GOLD DUST APARTMENTS Preliminary Drainage Report

Preliminary Drainage Report

10050 N Scottsdale Road, Paradise Valley, AZ

Josh Papworth, PE Senior Engineer

Appendix G - UNNAMED CHANNEL HYDRAULIC COMPUTATIONS

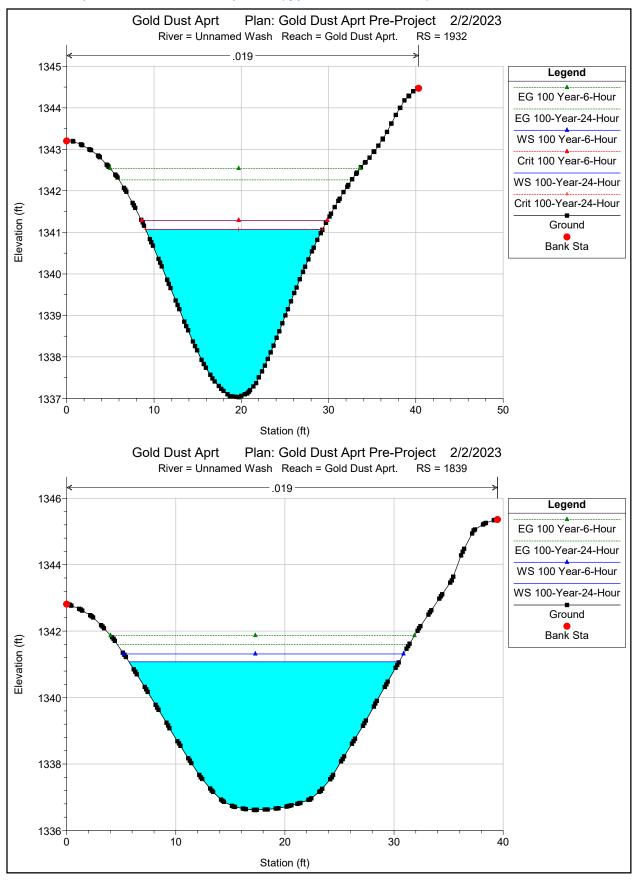
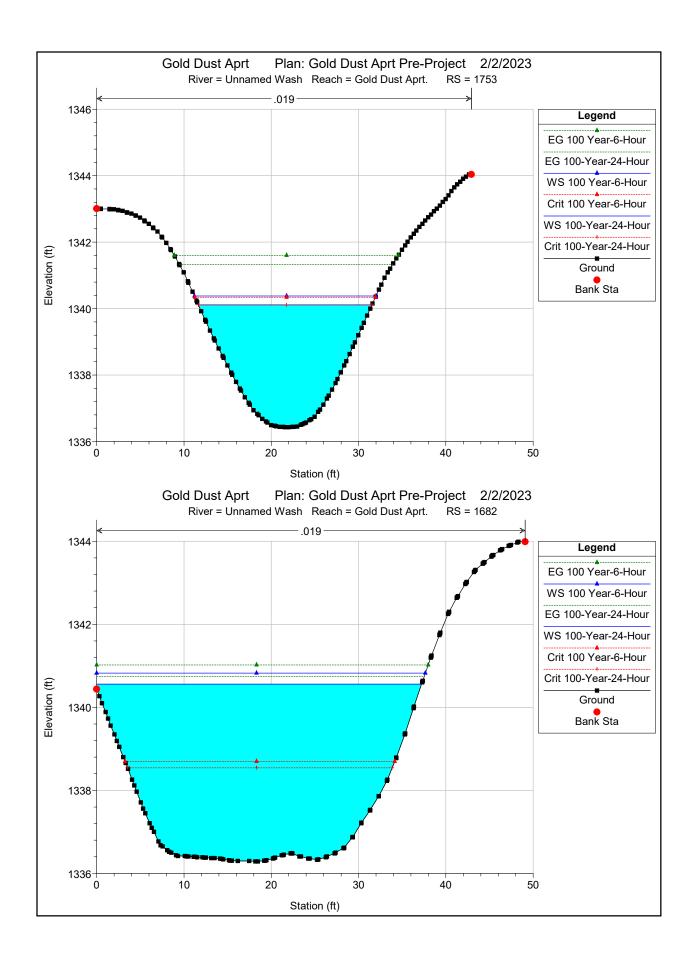
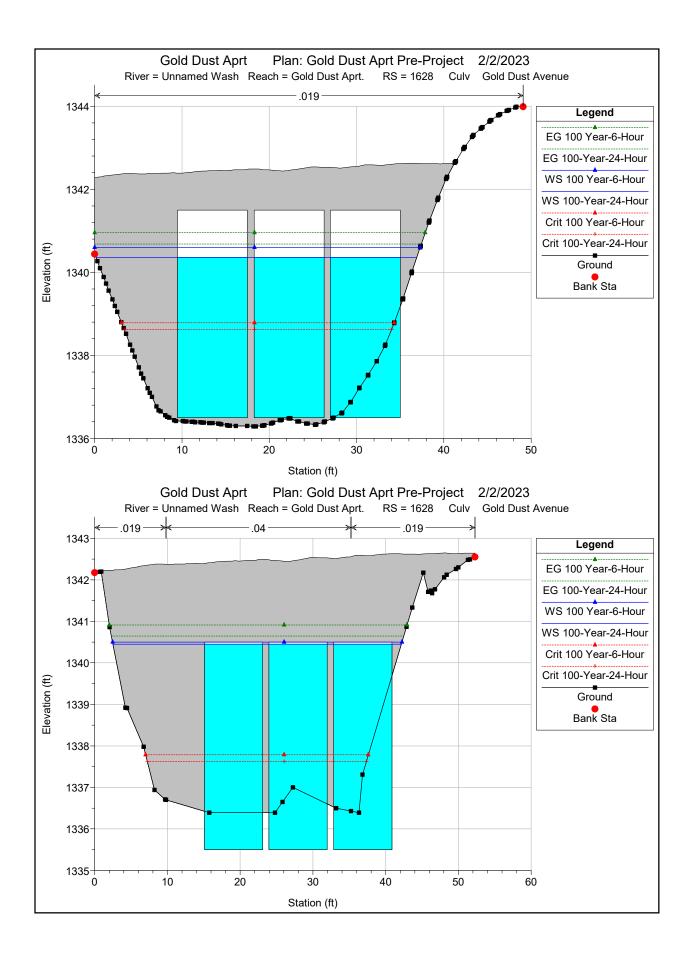
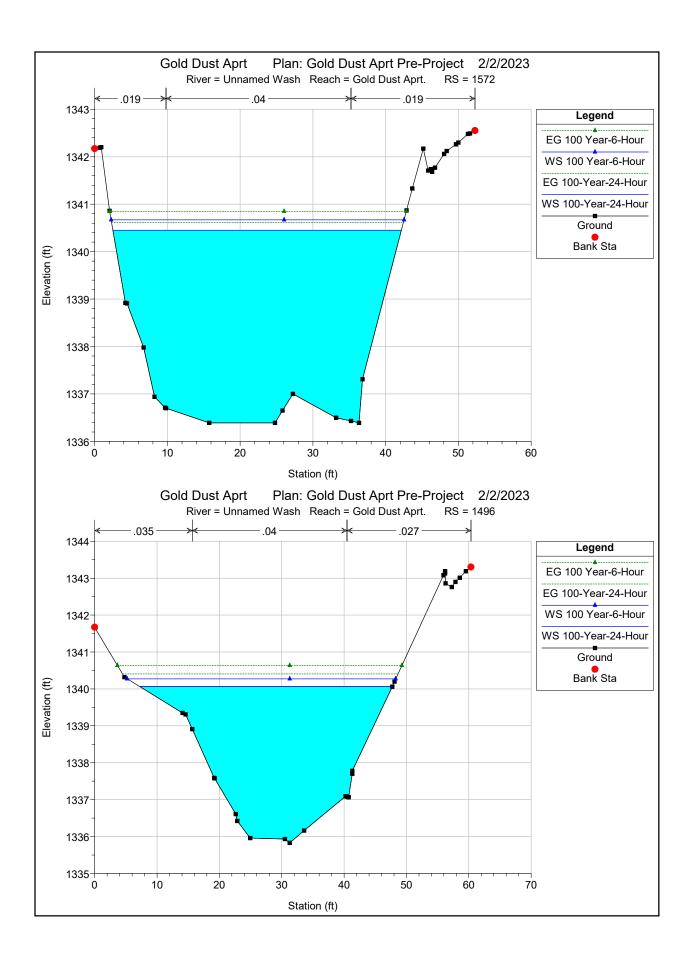
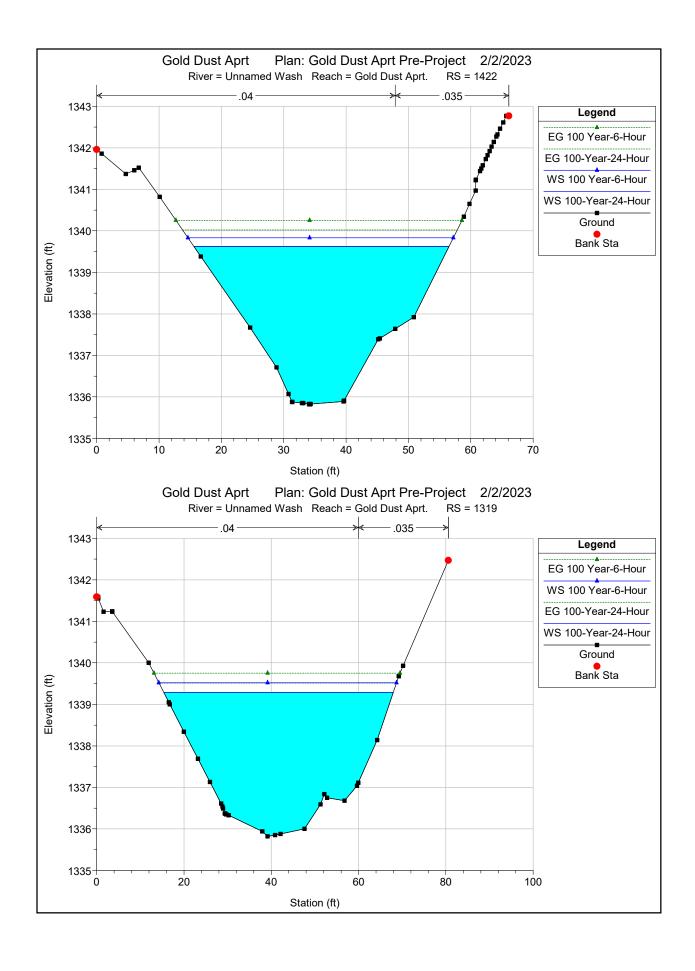
The n-value of 0.019 is not mentioned in the report. Where did it come from? Also, all bank stations are at the limits of the cross sections, please revise in final plans. (typ for all HEC-RAS)
